DANFOSS SOLENOID VALVE

AIR CONDITIONING (REFRIGERATION) SYSTEM

CATEGORY 3AINTAKE WHISTLE - UNDERWING A.C.U.

AIR CONDITIONING CONTROLS

**Fig. 1 Modification of the wiring of the 'Upper' (Ventilation) Switch.**

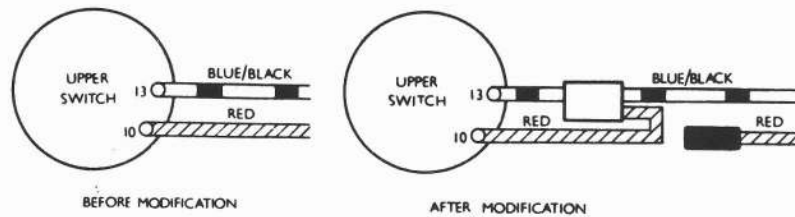
Remove the red wire from terminal 10 of the switch and tape it back.

Remove the blue/black wire from terminal 13 of the switch and cut the wire approximately one inch from the Lucar socket. Fit connector nipples (UD.2141) to the two cut ends and plug them both into a double connector (UD.1806). Fit a three inch length of red 14/.012 wire to the same connector and fit a Lucar socket (UD.6072) and sleeve (UD.6119) to the free end of the wire.

Reconnect the blue/black wire to terminal 13 of the switch and connect the new red wire to terminal 10.

Figure 1 - Vacuum valve assembly

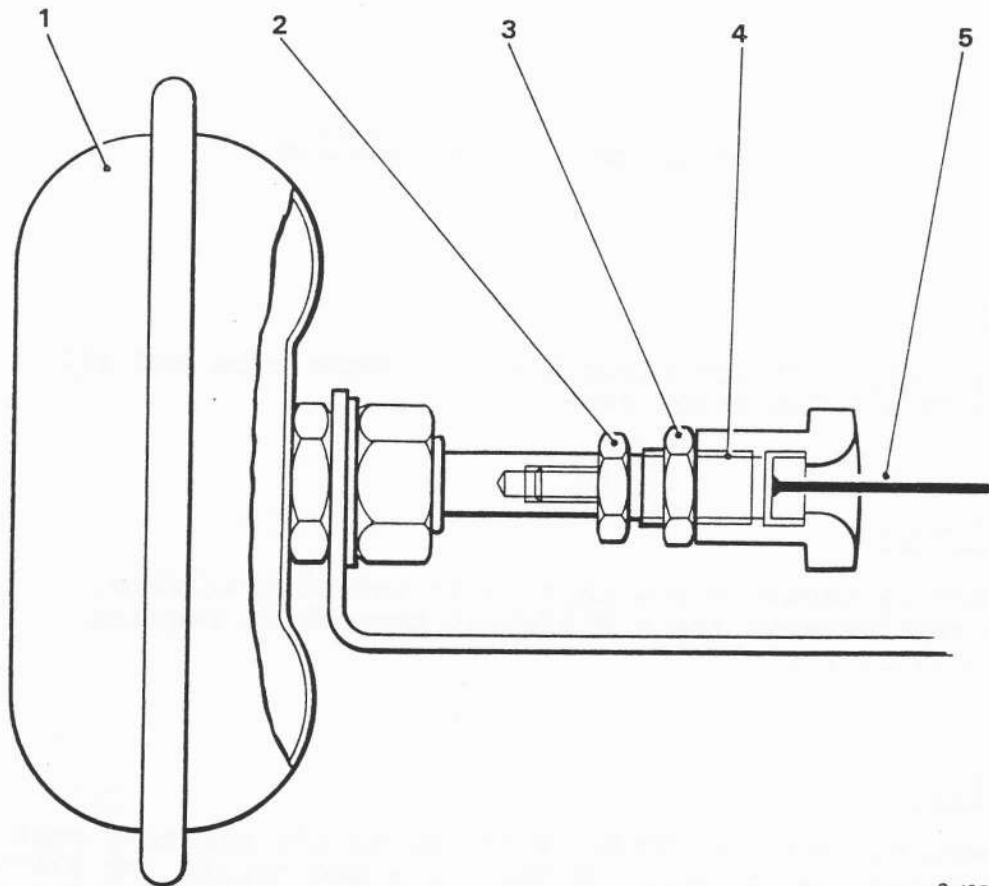
The existing vacuum valve unit is no longer available. Future replacements are a different type which require additional parts.

A screwed adapter (RH 9098) is fitted to the existing push rod on the vacuum valve unit. A new cable and nipple (RH 9100) is fitted, this being attached by means of a retainer (RH 9099) and retaining lock-nut (RE 22430). These are screwed and locked to the adapter (refer, Fig. 1).
